## ORIGINATION FORM

### Proposed Revisions to a Standard Plans Index (Please provide all information — Incomplete forms will be returned)

Index Number: 700-041

Index Title: Span Sign Structure

BASE PLATE CONNECTION

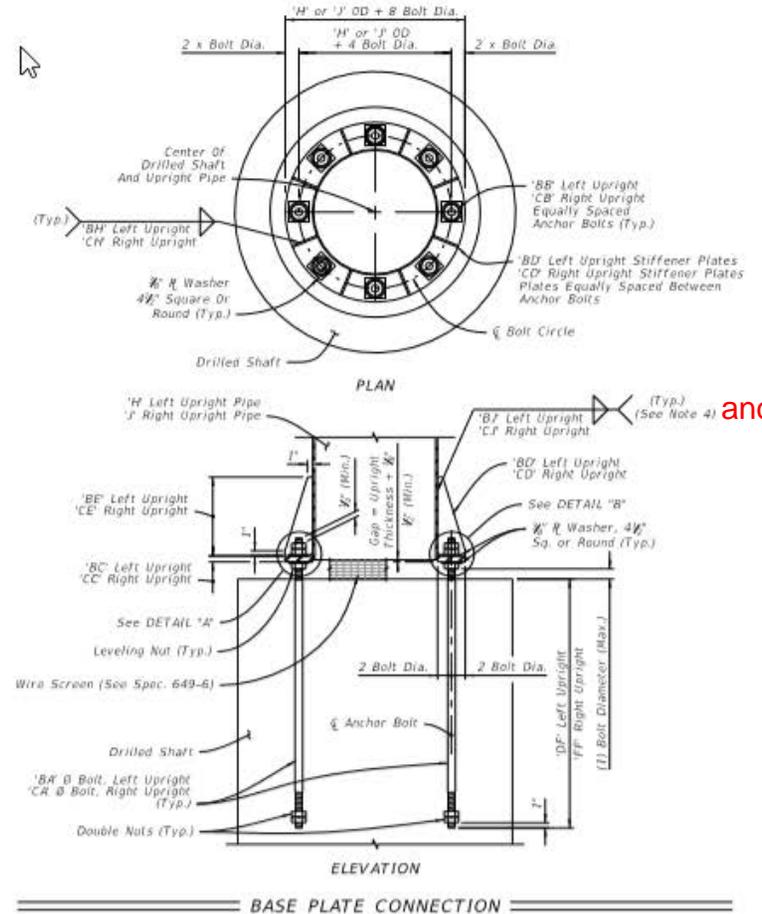
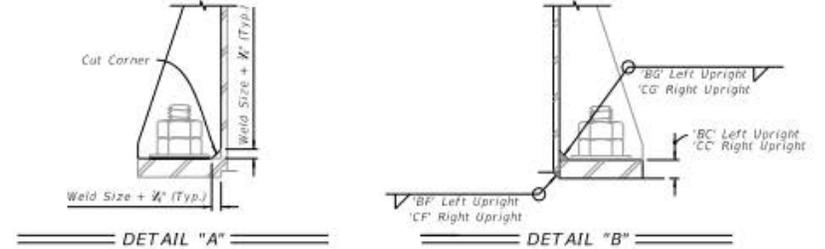
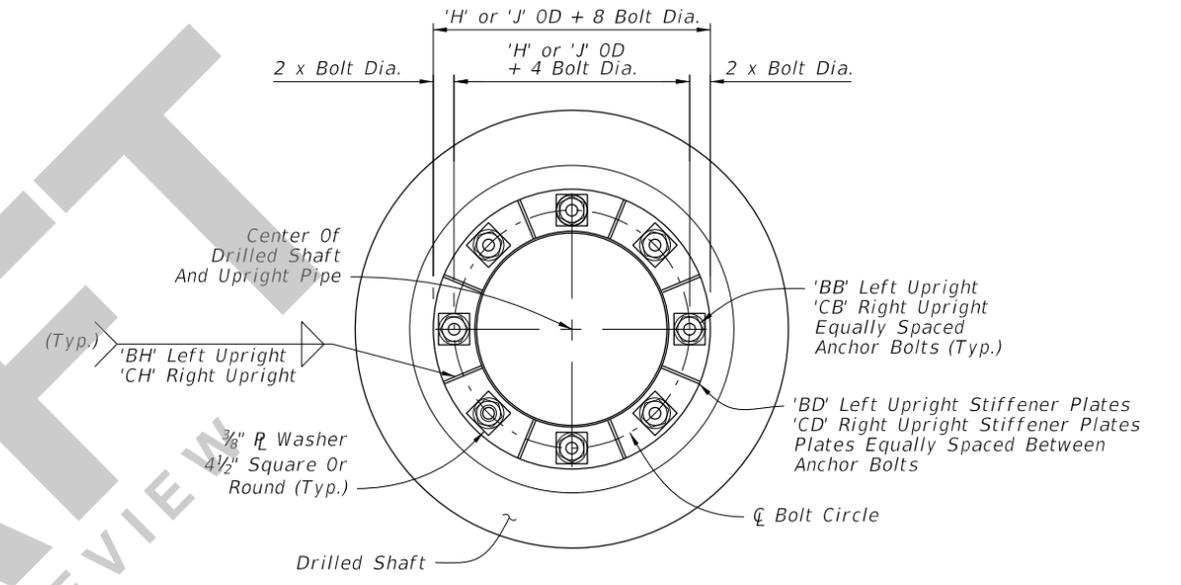
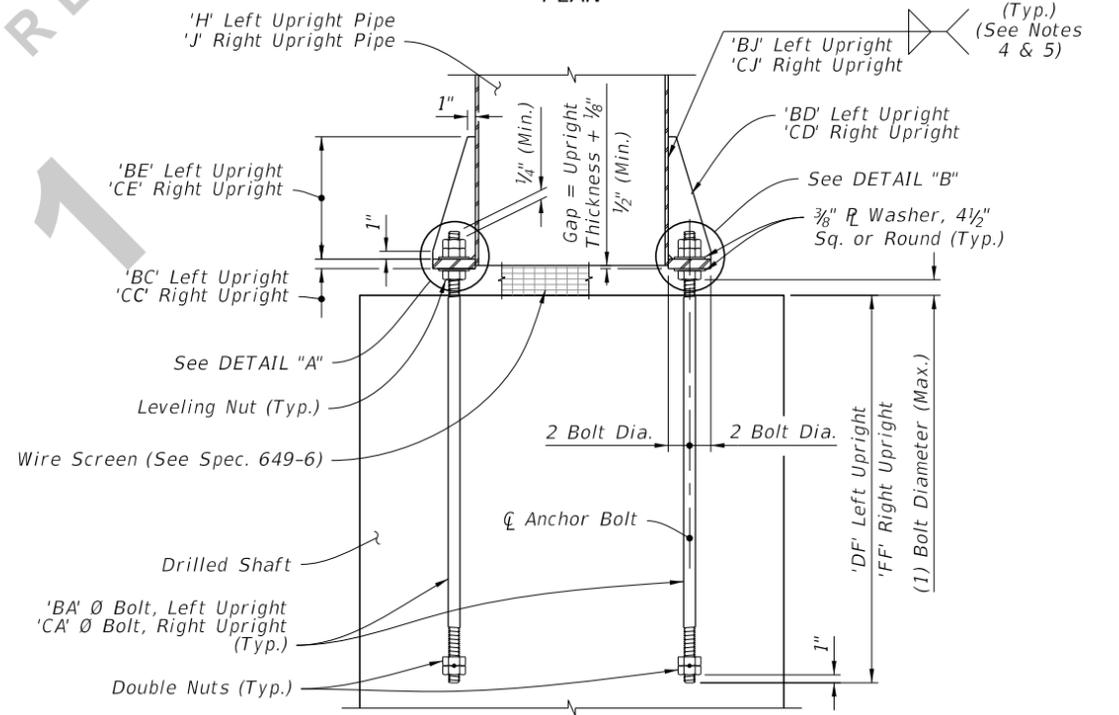
Added Note 5 and reference to the note.

Due to issue with tearing at the top of the stiffeners, adding a requirement for extra testing when poles are greater than 0.5" thick.

5. Provide Ultrasonic Testing for Lamellar Tearing when wall thickness exceeds 1/2"
